## MDNR Response to Specifically Identified RAIs

*Figure A Pathway Contributions to Building Surface Source Term TEDE*

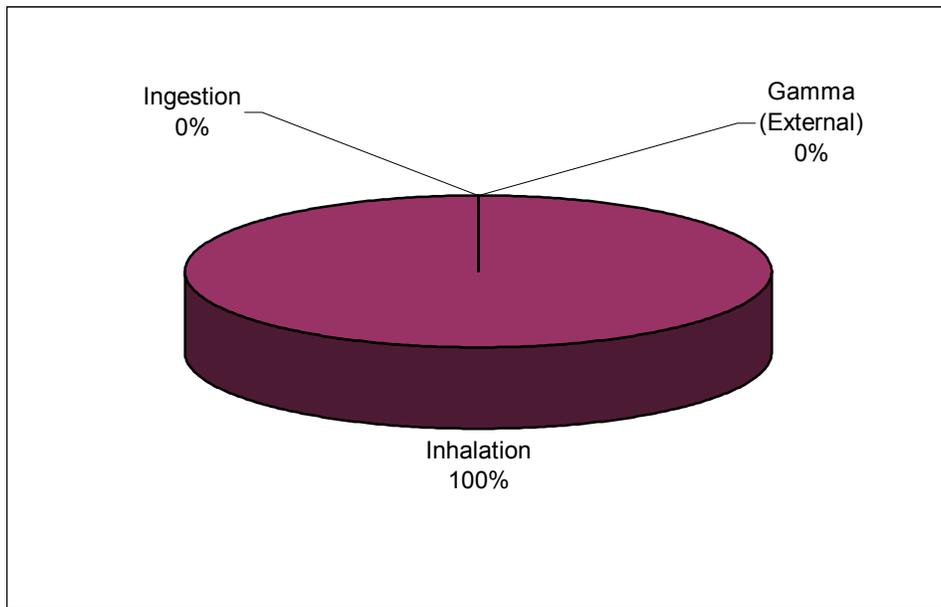
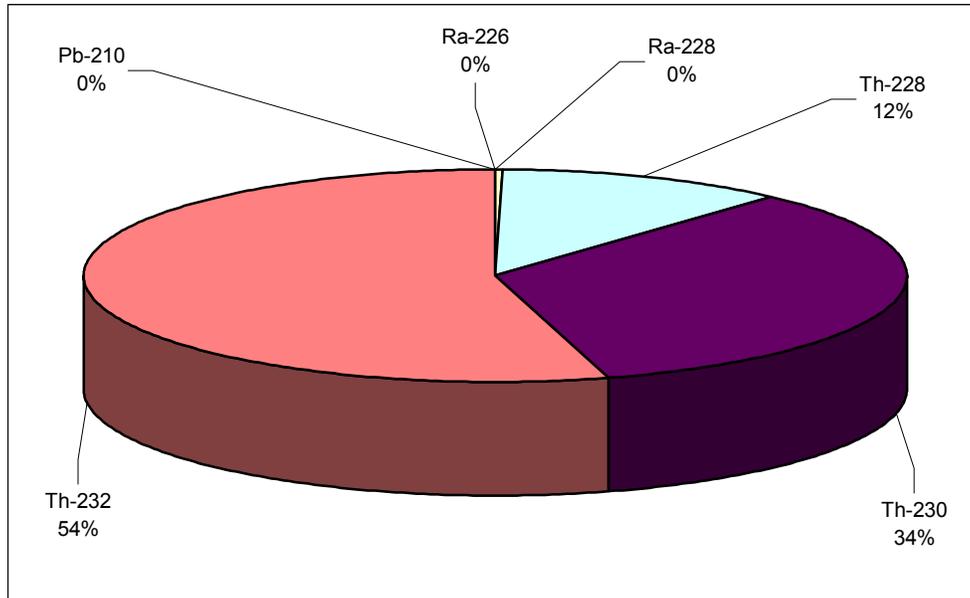
**Section 5.9, Page 5-95.** The current text discusses the results of the RESRAD modeling with regard to development of both the subsurface and surface soil DCGLs but does not include a discussion of the results of the DandD modeling. The following discussion supplements that found in Section 5.9:

A review of the computer modeling output of the DandD code (Attachment 3) reveals that exposure from the inhalation pathway dominates the potential future dose. The thorium isotopes (Th-232, Th-230, and Th-228) are the most significant contributors to

total effective annual dose. Figure A and Figure B illustrate the relative pathway and isotopic contributions to total effective dose equivalent resulting from the building surface DCGL.

Figure 9-2 Decommissioning Management Positions

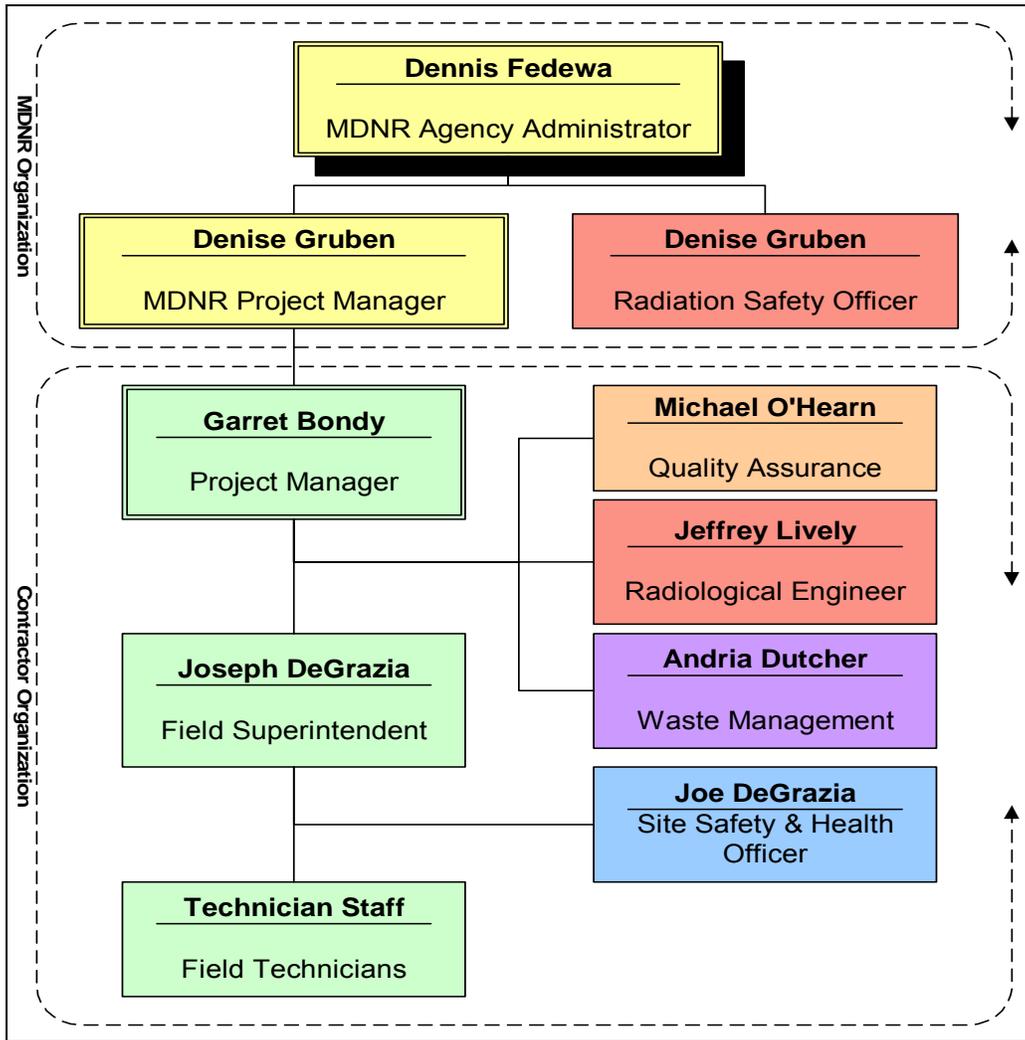
**Figure 9-2, Page 9-5, (Organization Chart).** A revised organization chart is provided to reflect personnel changes in key management positions.
